Addendum 1

Questions and Answers from Potential Bidders

LGPC New Building Project
IFB's C20190100 and C20190200
March 29, 2019

5 GRINDER PIT DETAIL
3/4" = 1'-0"

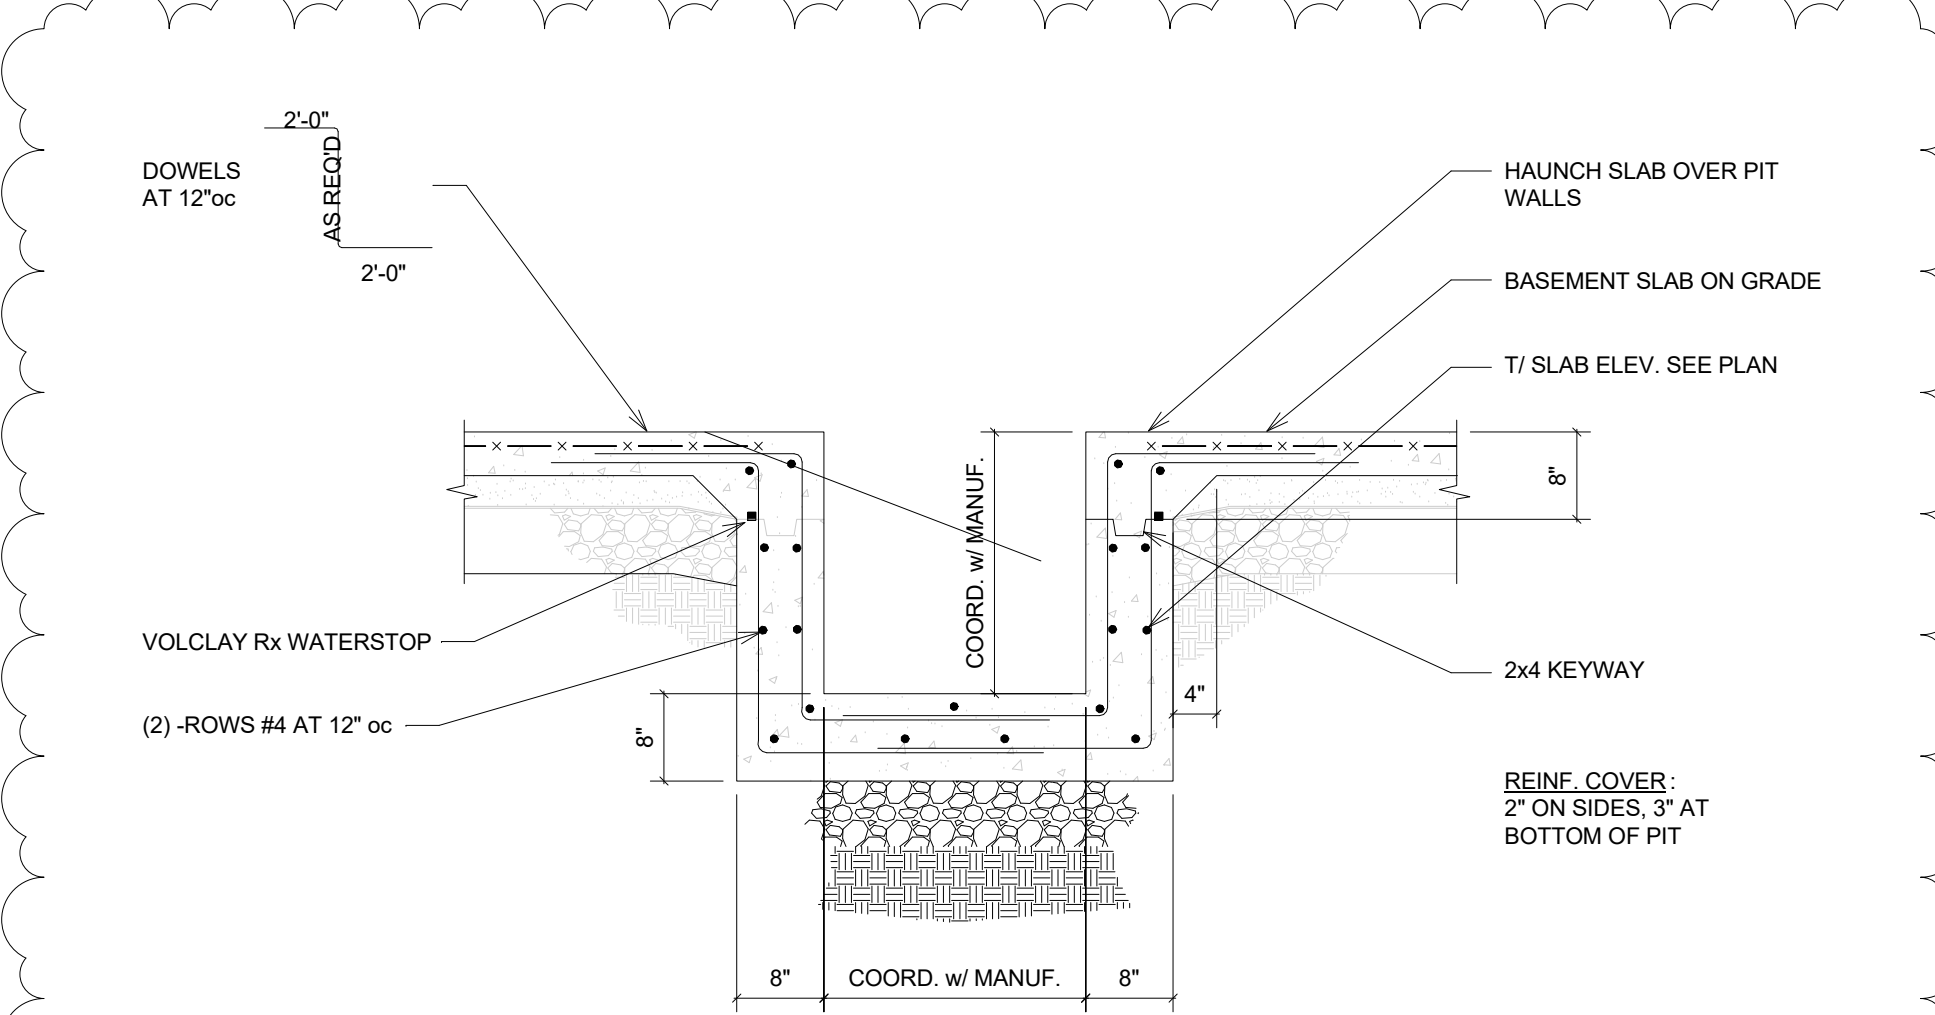
37. Can you provide details for the grinder sump pit?
Yes. See revised sheet S202.
